Appendix IV

NRC Staff Computational Fluid Dynamics Simulations in Support of the SONGS Audit

**Figure 10: Increased Mesh Resolution Case
Containment Pool Velocity 3 Inches Above Floor [ft/s]**

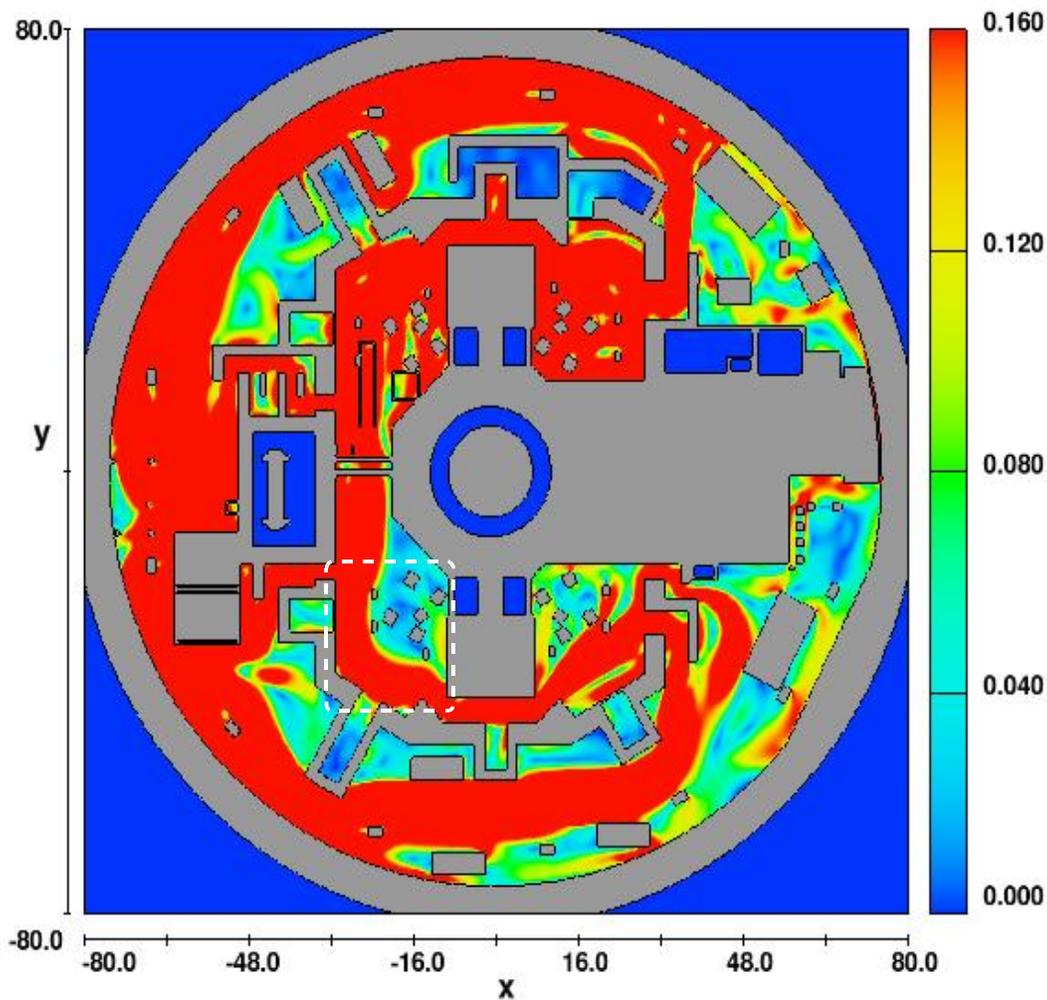
Although there are several minor differences between Figures 9 and 10, these are inconsequential with respect to debris transport. This observation indicates that the differences in containment pool flow observed in Figures 9 and 10 when compared to Figure 1 are likely the result of the refined mesh (and increased simulation time), not the difference in the pool depth at which they were generated.

**Figure 11: Extended Simulation Time Case
Containment Pool Velocity [ft/s]**

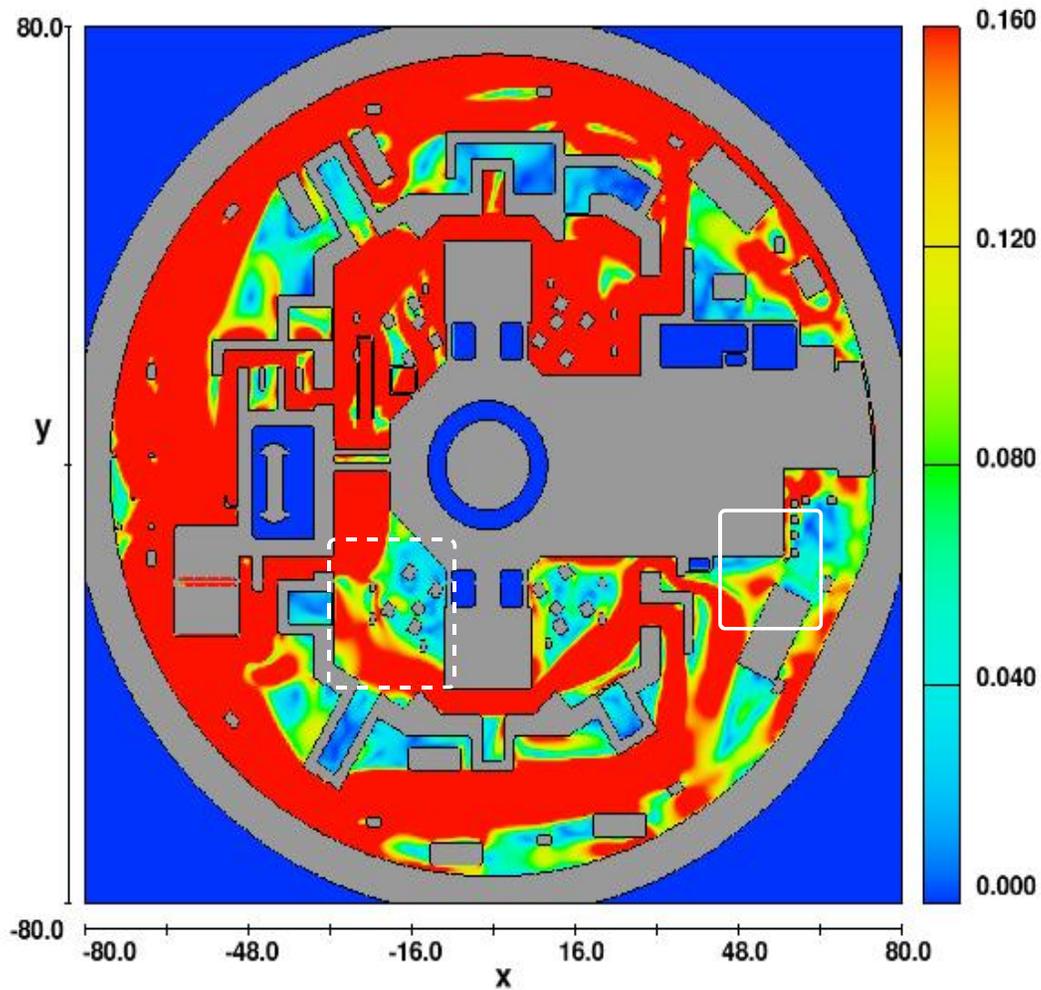
While, once again, the global flow pattern in containment is not significantly affected by the increased simulation time, several interesting changes to the flow field can be noted. Two of the most notable changes with respect to the debris transport analysis are highlighted on Figure 11. First, the dashed-line box on Figure 11 shows the velocity magnitude contours in the southwest corner of the Loop 2 compartment at a simulated time of 750 seconds. Figure 6 displays a velocity field of similar magnitude in this local region at 500 seconds. In contrast to these two plots, Figure 1 shows significantly lower velocities in this region at 300 seconds of simulated time. The comparison of these figures suggests that the velocity field in the southwest corner of the Loop 2 compartment has not been fully resolved at 300 seconds. This observation is further confirmed by sequentially examining several of the velocity magnitude contour plots for the three cases prior to 300 seconds (not shown in this appendix), which clearly indicate that the flow in this region is still rapidly developing. It is also noted that the area within the dashed-line box was previously examined on Figure 9, which presented the results of the increased mesh resolution case. By comparing Figures 9 and 11, the impact of the refined mesh can be appreciated in comparative isolation because the slight difference in run time for these two cases is not expected to have a significant impact on the simulation results.

The second noteworthy observation from Figure 11 is highlighted by the solid-line box in the southeast quadrant of the containment. This figure shows that, at 750 seconds of simulated time, the velocity field in the vicinity of the refueling canal drain line appears to be approaching the threshold at which some small pieces of mineral wool washed-down through the drain line could be transported to the recirculation sumps via tumbling. Note that the predicted flow field in Figure 11 for this region contrasts with that of Figure 1, which appears to indicate that small pieces of mineral wool washed down through the refueling canal drain would be highly unlikely to reach the recirculation sumps. Further consideration of Figure 6 indicates that, unlike the flow in the southwest corner of the Loop 2 compartment discussed above, the flow field in the region enclosed by the solid-line box has not completely developed, even at 500 seconds.

The two observations discussed above suggest that, while terminating CFD simulations based upon visual indications of mean kinetic energy versus time plots may be adequate for determining that a steady global containment pool flow pattern has been established, this criterion alone may not be generally adequate for concluding that predictions of localized flows with potential significance to the overall debris transport results have reached nearly steady-state conditions. (Recall that, as demonstrated by Figures 2 and 3, both the estimated mean kinetic energy and average turbulent kinetic energy had appeared relatively stable after a simulation time of 300 seconds for the baseline case.) As may be inferred from the observations cited above, local regions where the achievement of steady-state flow conditions may require additional time can often include areas where obstacles or constrictions are present, which tend to complicate predictions of the flow field. The staff found that using the FLOW-3D output files to examine of the progression of the CFD solution at various times prior to the simulation termination was useful in evaluating whether sufficient convergence had been achieved in local areas of potential importance to the debris transport results.

Despite this general concern with the licensee's methodology for terminating CFD simulations, the staff did not consider the SONGS debris transport results to be non-conservative because (1) debris settling was not credited in the southwest corner of the Loop 2 compartment where velocities were underpredicted in the baseline case and (2) staff sensitivity simulations, including Case 1-5 (Increased Containment Spray Flow Case), Case 1-6 (Increased Refueling

Figure 12: Elimination of Containment Spray Alternating Horizontal Velocity Component Case, Containment Pool Velocity [ft/s]

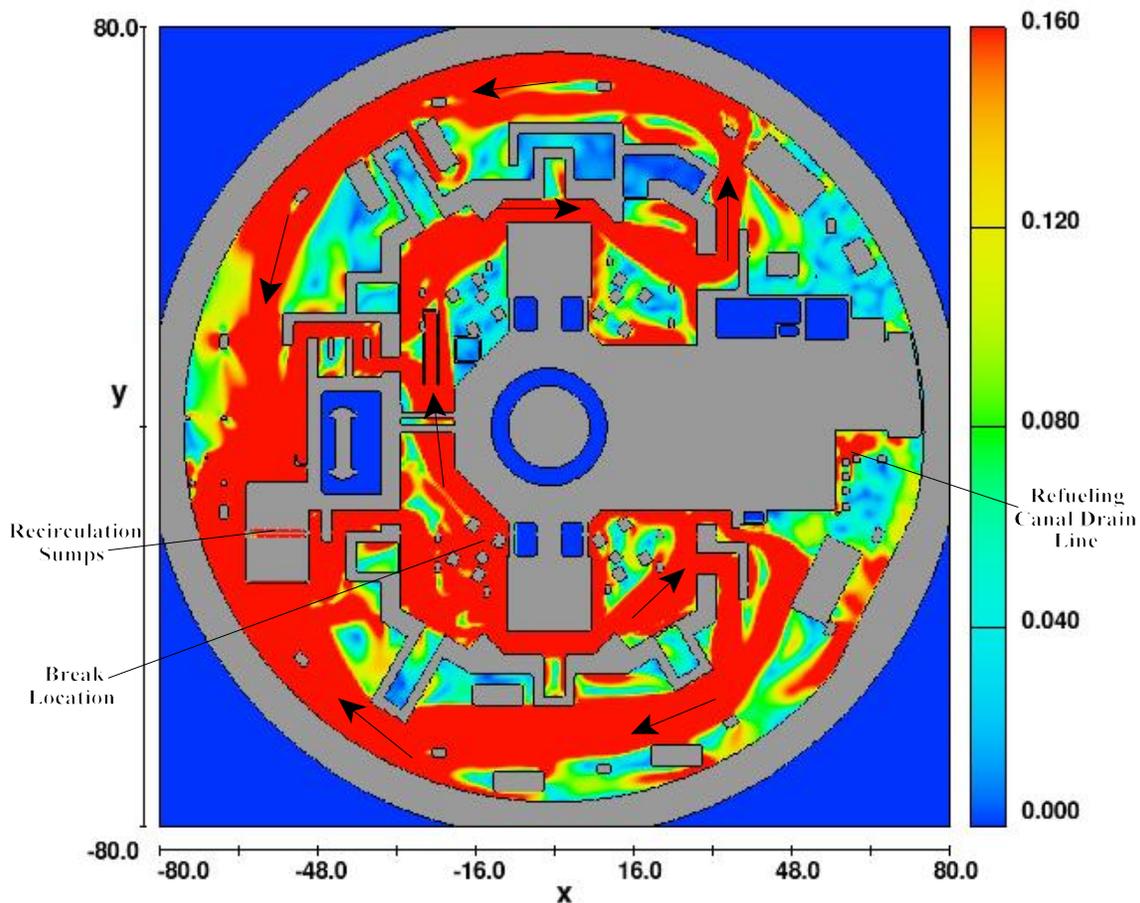
The staff noted that the containment pool velocity magnitude contours displayed on Figure 12 are very similar to those depicted in the corresponding figure in the licensee's debris transport calculation, Figure 5.9.29 [1]. Several minor differences were noted between the two figures, none of which appeared to have significant implications with respect to the debris transport results. Note also that slight differences are expected between Figure 12 and Figure 5.9.29 [1] as a result of the difference in the run times for the two cases and possibly the staff's input deck modification that removed the horizontal component of the containment spray vector.

Similar to the discussion for Case 1-4, the staff noted that the predicted flow field in the locations where containment spray is introduced to the model, particularly the regions near the containment wall on the west and south (i.e., left and bottom) of the containment pool, does not appear to be significantly affected by the removal of the alternating horizontal velocity component. As a result of this observation, the staff concluded that the presence of the alternating horizontal component of the spray vector did not appear to significantly influence the overall debris transport results for either the Case 1 or the Case 2 break.

**Figure 13: Southeast Passage Blockage Case
Containment Pool Velocity [ft/s]**

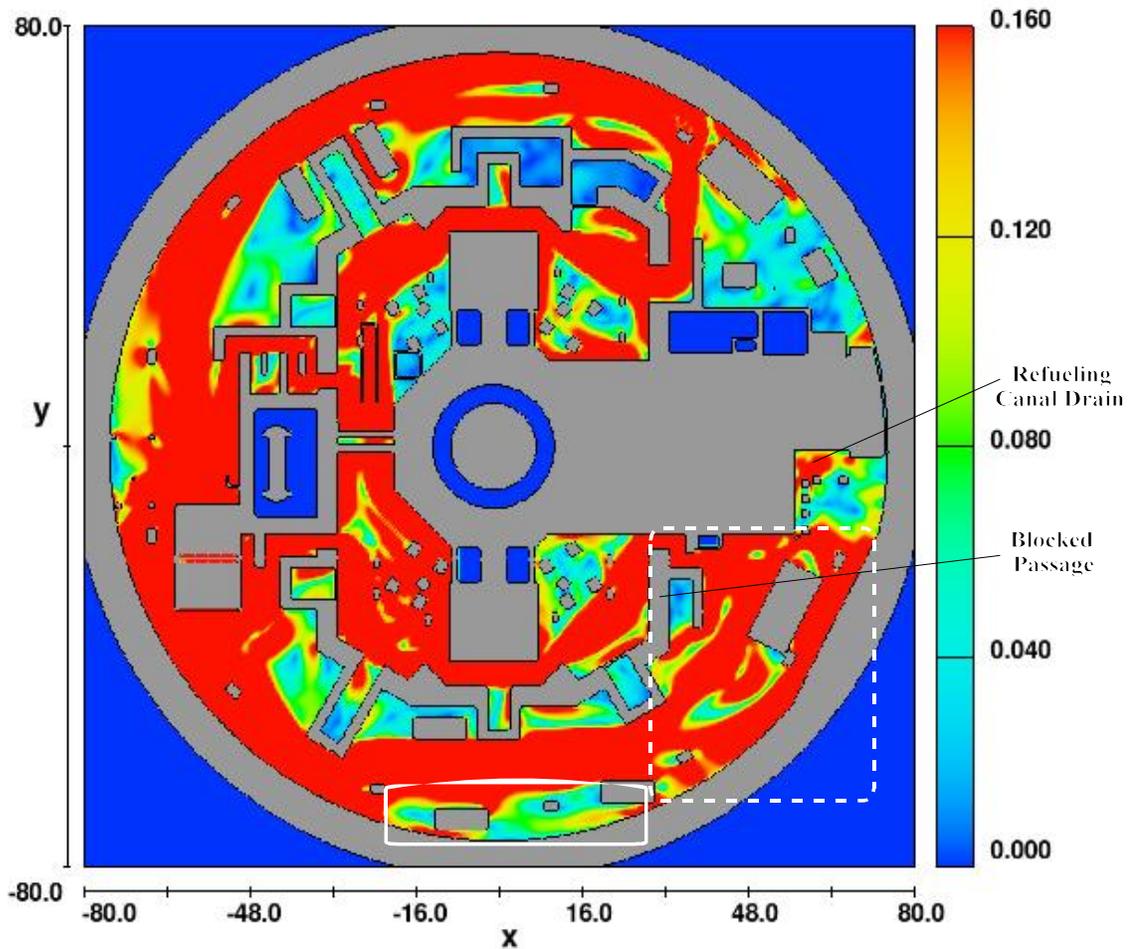
While the overall flow pattern in Figure 13 is similar to that of Figure 12 (which essentially serves as the baseline case for the Case 2 break), the flow velocities in a substantial portion of the southeast quadrant of the containment pool (highlighted in a dashed-line box on Figure 13)

appear to be increased by the explicit modeling of blockage at the lower southeast passage. Prior to running the simulation, the staff was concerned that these increased velocities could lead to additional transport of debris washed down through the refueling canal drain and along the south containment wall (highlighted in a solid-line box on Figure 13). However, Figure 13 indicates that local changes in the flow velocity do not significantly impact the refueling canal drain line area or the size of the low-velocity zone along the south containment wall.

Based upon the initial debris spatial distribution assumed by the licensee (refer to Section 3.5.3.1 of the main report), the flow velocity increases in the southeast quadrant do not significantly affect the overall debris transport results. However, the extent of the velocity increases shown in the southeast quadrant of Figure 13 could not have been fully appreciated prior to running the simulation. Therefore, while these perturbations were not ultimately significant for either the Case 1 or Case 2 SONGS input decks, their order of magnitude suggests that the area-based methodology used for computing debris transport fractions (this methodology is described in Section 3.5.4.2 in the main body of this report) could yield non-conservative results if applied in a similar manner to geometric and analytical conditions that may exist for other plants.

Figure 14: Southeast Passage Blockage Plus Increased Refueling Canal Drainage Flow Case, Containment Pool Velocity [ft/s]

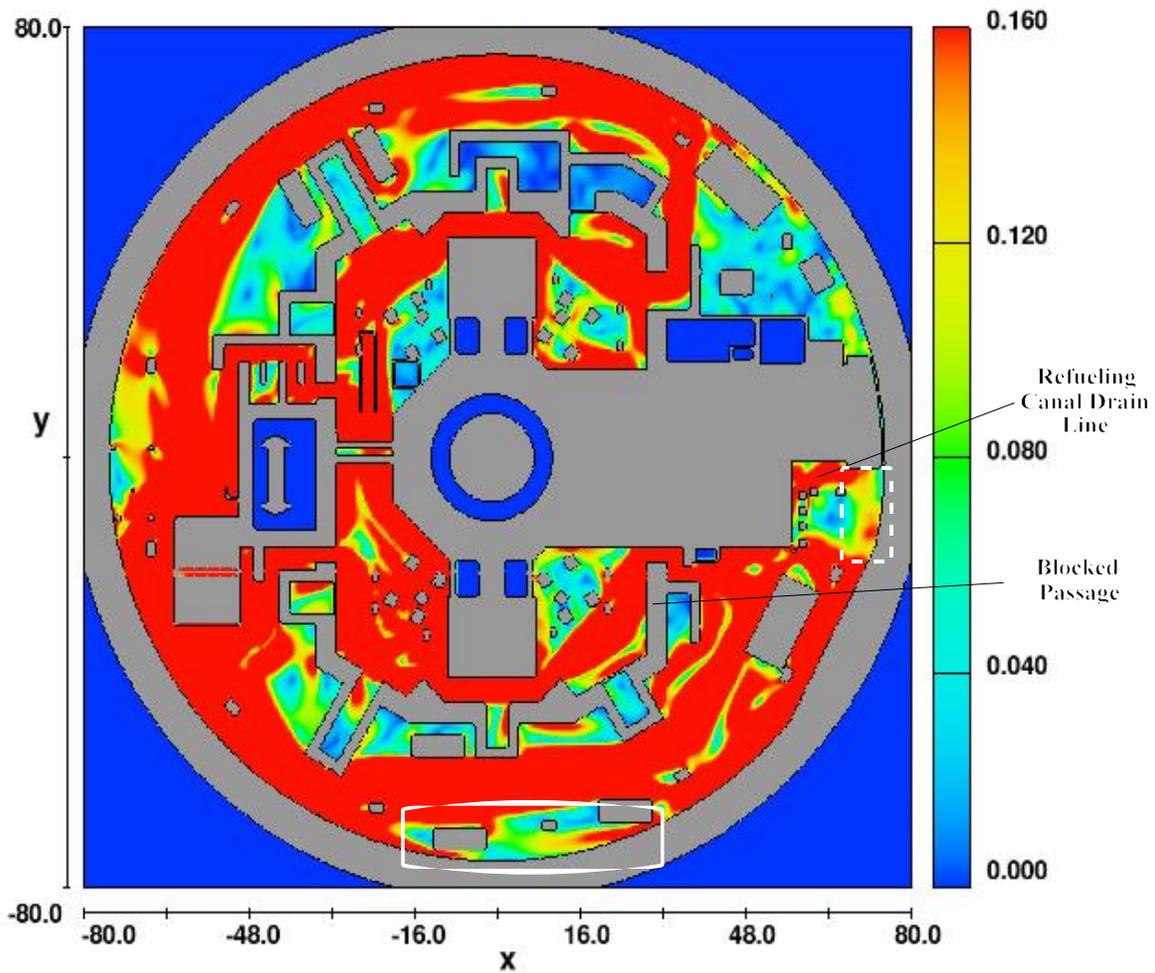
A comparison between Figures 13 and 14 reveals relatively minor differences when a 30% increase in the refueling canal drainage flow is explicitly considered. A dashed-line box on the east side of the containment near the refueling canal drain line shows one area where velocity increases are noticeable but not on the verge of continuously exceeding the 0.16-ft/s tumbling transport metric for small pieces of mineral wool. The solid-line box against the south wall of the containment shows that significant changes were similarly not predicted in the enclosed low-velocity region.

Based upon the results of this sensitivity simulation, the staff has confidence that small pieces of mineral wool washed down through the refueling canal drain line would not transport to the recirculation sumps and that the licensee’s transport analysis is relatively robust in the face of credible perturbations to the CFD model.
